CHANGE ORDER NO.

PROJECT: Flamson MStemporary Campus
Paso Unified School District

RE: Flamson Temp Campus
CCD 03 Grading and Utility Revisions (CPR's 02, 07R1)
Change Order Request: COR 03

Project Name: Flamson MS - Temp Campus/Interim Housing
Construction Change Document No. 03

Sheet AS1.0 Change Description List:

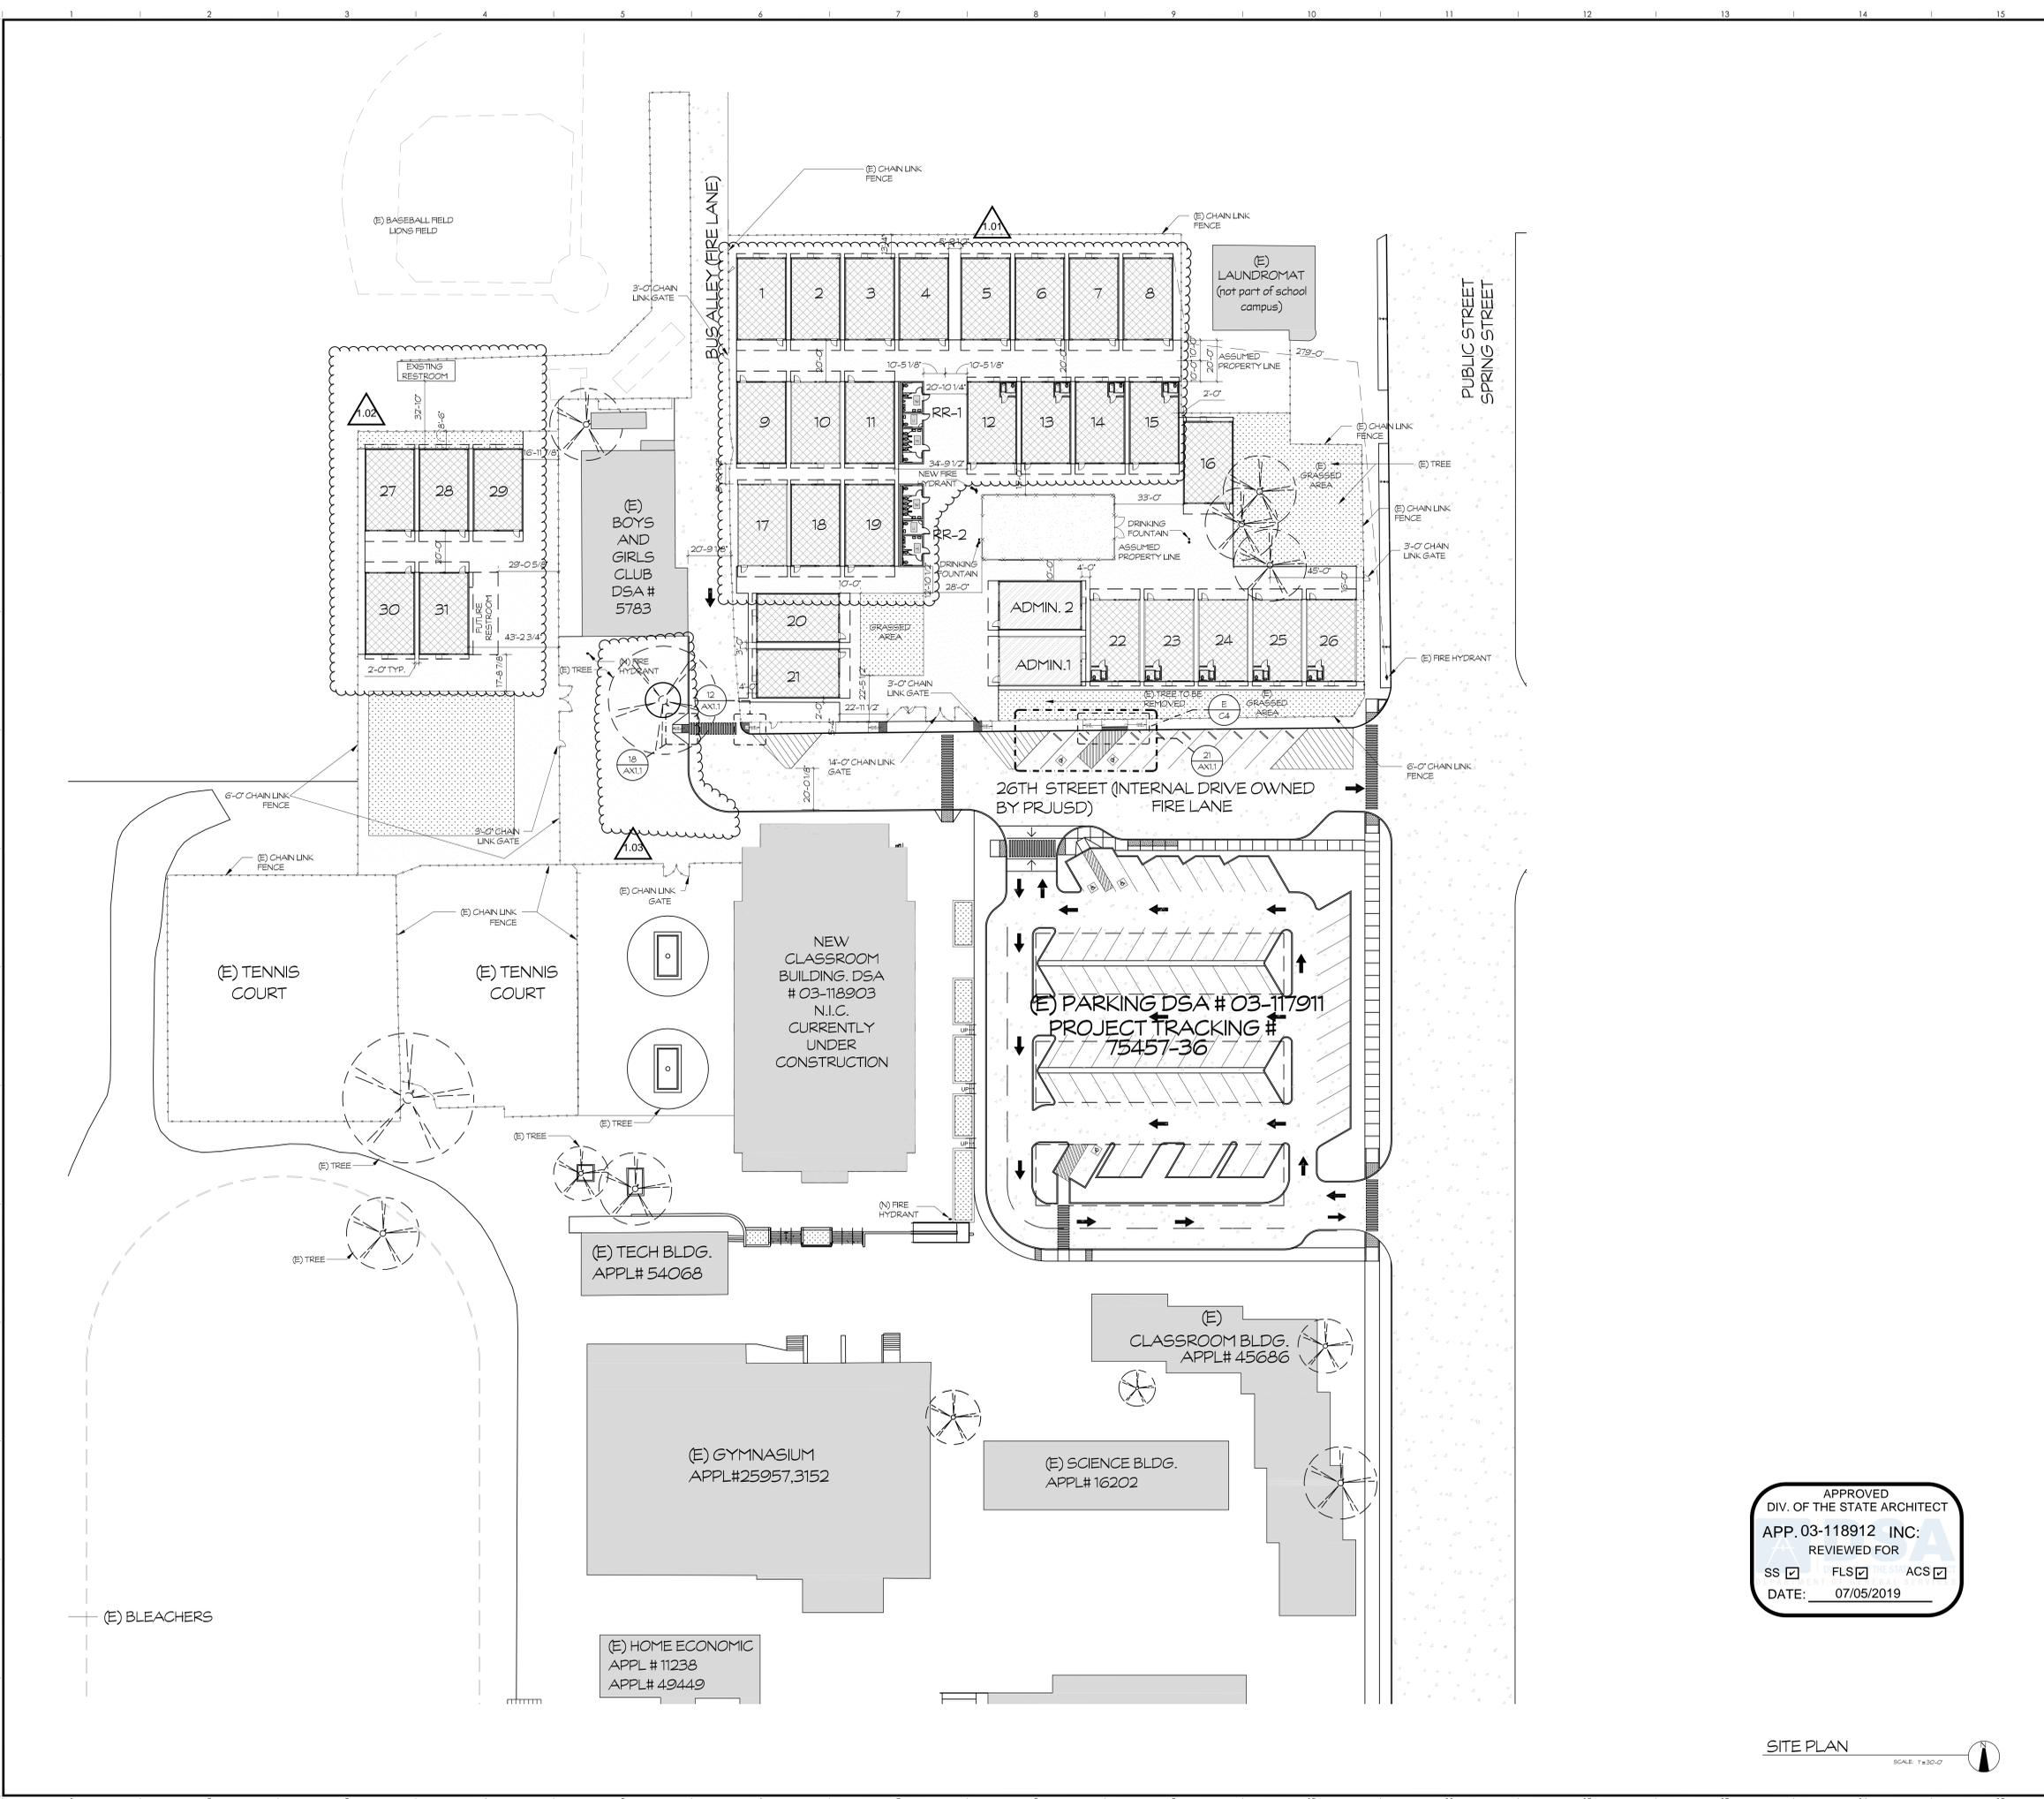
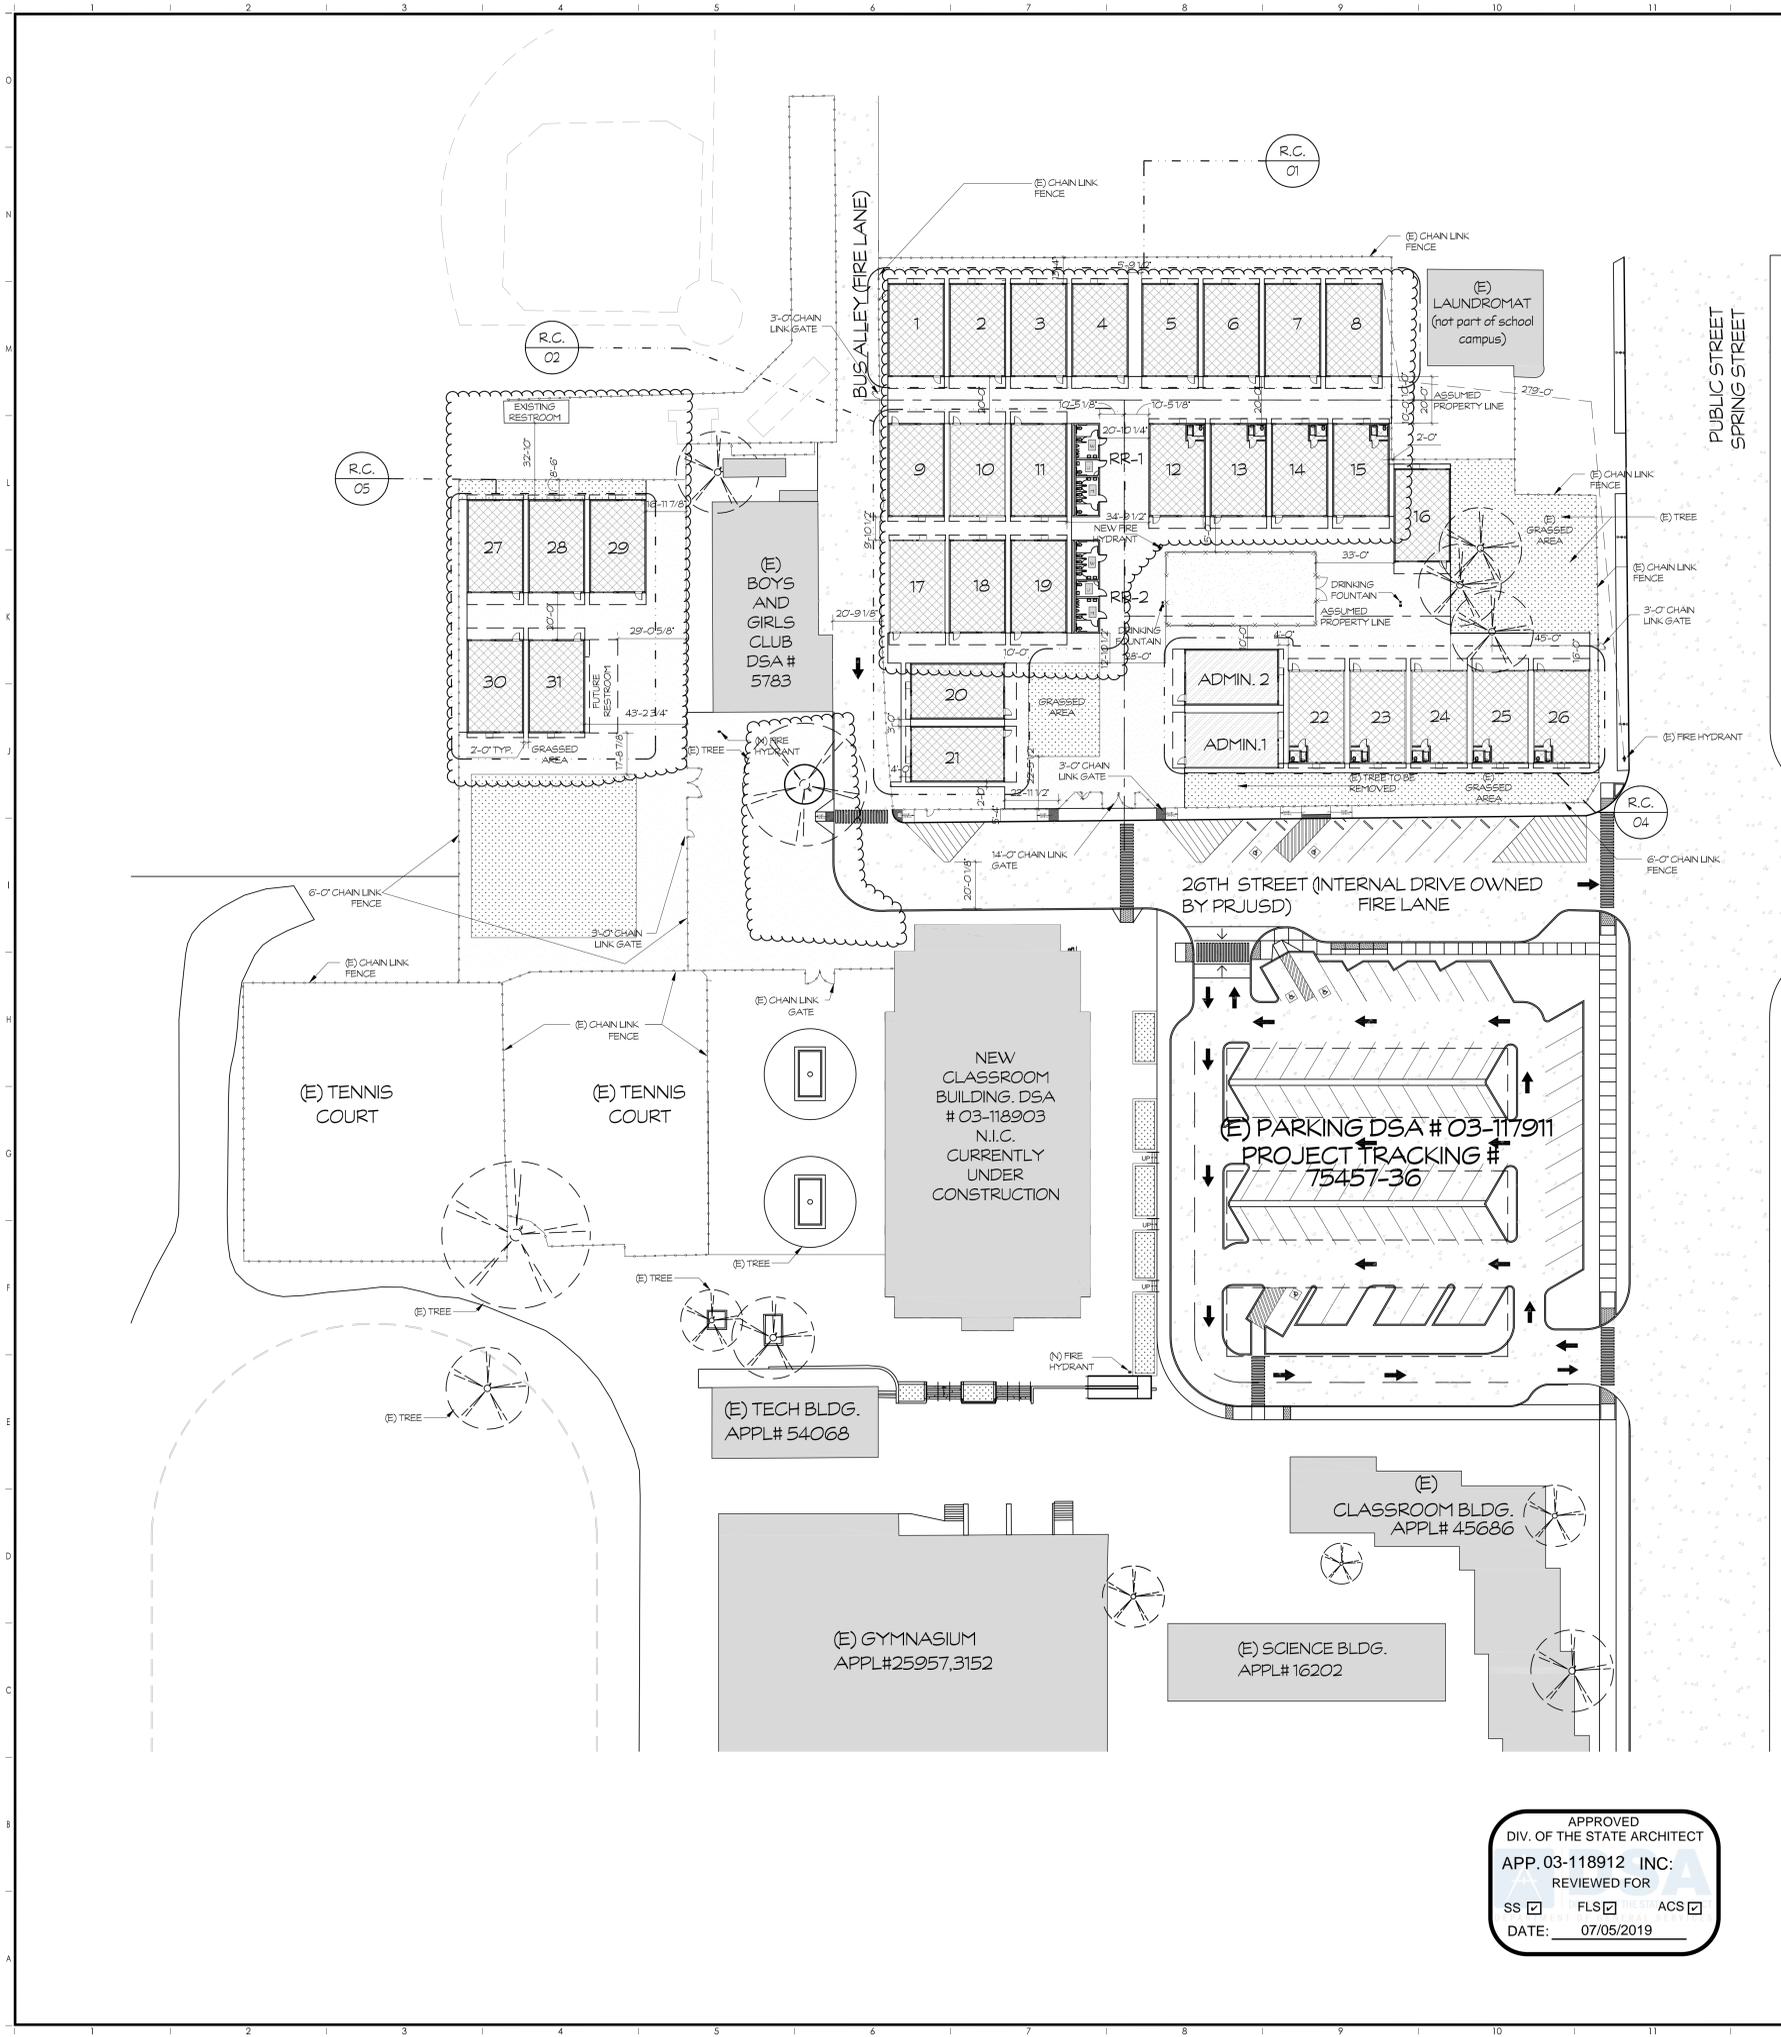
- 1.01 Modular buildings 1 through 19 shifted 3'-0" South to allow for a 3'-0" wide leveled surface area North of units 1 through 8 in accordance with code sections CEC/NEC 110 and CBC 1808.
- 1.02 Modular buildings 27 through 31 shifted 10'-0" South to allow for a minimum 20'-0" separation from an existing structure north of modular buildings 27 and 28.
- 1.03 Added flatwork area East of modular building cluster No. 5. Refer to DSA Approved sheet AT.4 for cluster location
